SIB 11 11 21

## RECALL 21V-907: EXHAUST GAS RECIRCULATION (EGR) COOLER – N47T LOW TEMPERATURE

This Service Information Bulletin (Revision 2) replaces SI B11 11 21 **dated May 2022**.

### PROCEDURE 1: REPLACE THE EGR COOLER

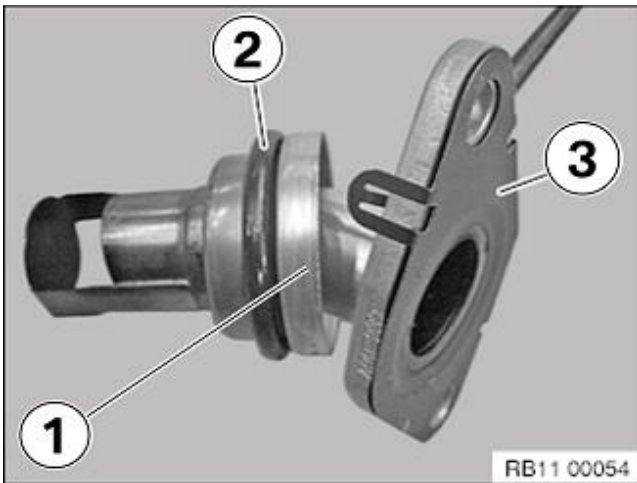
Record or take a photo of the following numbers on the new EGR cooler (1, 2 and 3). These numbers will be required later to register the new cooler in ISTA.

1. Production date [YY-MM-DD]
2. Revision index
3. Serial number

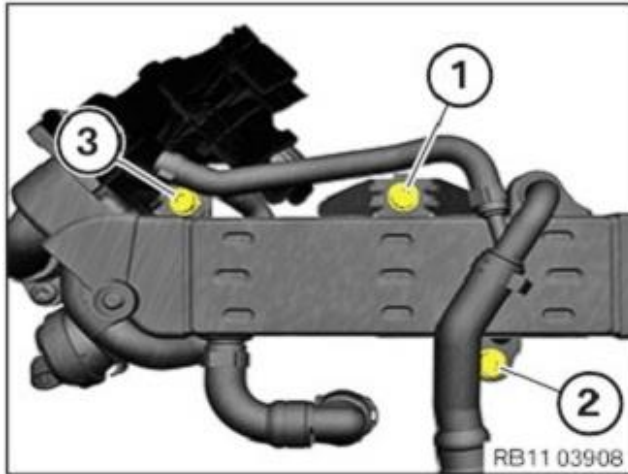
- When the old EGR cooler is removed:

- Remove the EGR pipe from the intake venturi pipe (replace O-ring (2) and gasket (3)).

- Inspect and clean (if needed) the EGR pipe. Wear protective equipment (eyes and hands) and clean out the excessive carbon using a degreasing agent and a brush (suitable brushes can be found in wheel brush kit 83 19 2 298 237).
- Reinstall the EGR pipe with new gasket and O-ring before installing the new EGR cooler.
- Install the new EGR cooler following the repair instructions.
- Replace the coolant line with temperature sensor 11 53 7 827 841

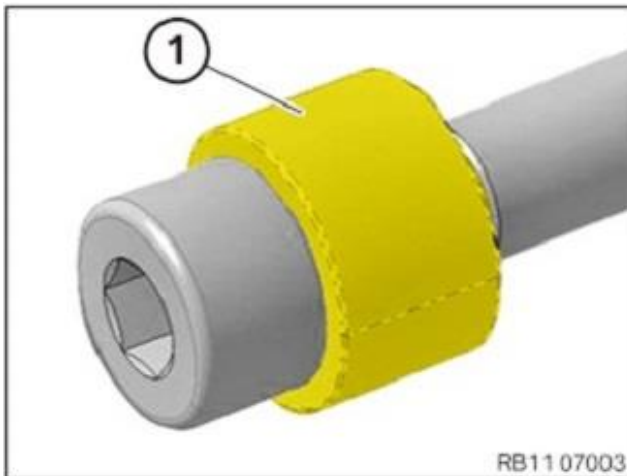
- Inspect highlighted screws before reusing.

- Replace the screws if they do not have the 10mm spacer (1). Use PN 07 14 9 886 429 (included in parts kit 11 71 8 490 650).

- Replace the vacuum hose PN 11 65 8 595 650 (enough hose for two repairs) from the changeover valve to the bypass flap on the cooler (measure the new hose and cut according to the old hose)
- The acoustic cover will be replaced with PN 11 14 8 490 570 (if an acoustic covered was installed)
